## Staff Report & Recommendations

### Lockwood Meadows Subdivision Lot 34 Accessory Dwelling Unit

#### Type II Review

(2024-025-ADU) October 9, 2024

# Site Plan

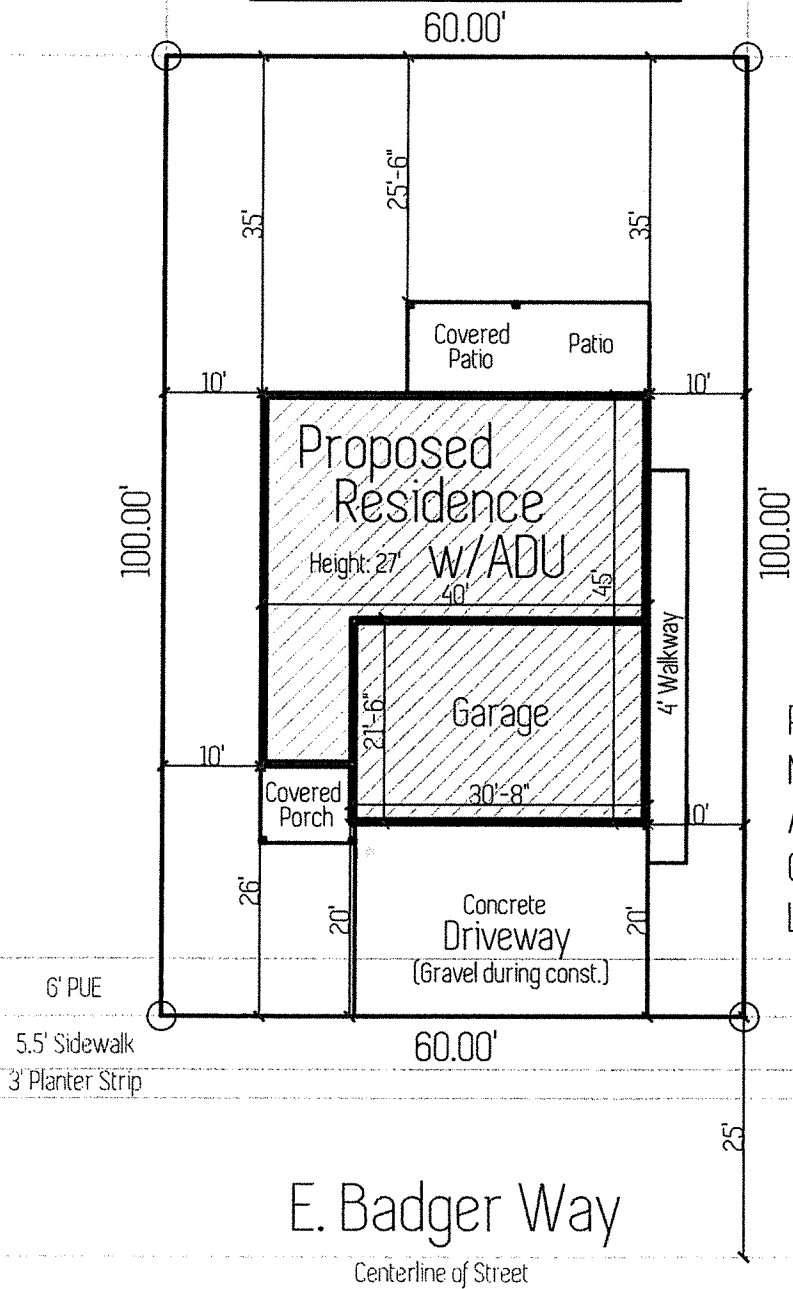
**Findings:** The proposed attached ADU is located on the east side yard of the primary residence. It will be setback approximately ten (10) feet from the interior property line. The setback criteria meets the requirement.

**Findings:** Single-family dwellings are required by LCMC Table 18.280.030 to have two off-street parking spaces. The proposed home and accessory dwelling unit has a three-car garage and driveway fulfilling this requirement. The ADU will have its own attached one-car garage, exceeding the minimum additional off-street parking requirement.

**Findings:** As indicated in the provided plans from the applicant, the ADU will take access from the three-car driveway.

**Condition 4:** The applicant shall construct the driveway improvements as shown on the approved site plan and meet International Fire Code fire access standards prior to issuance of the occupancy permit.
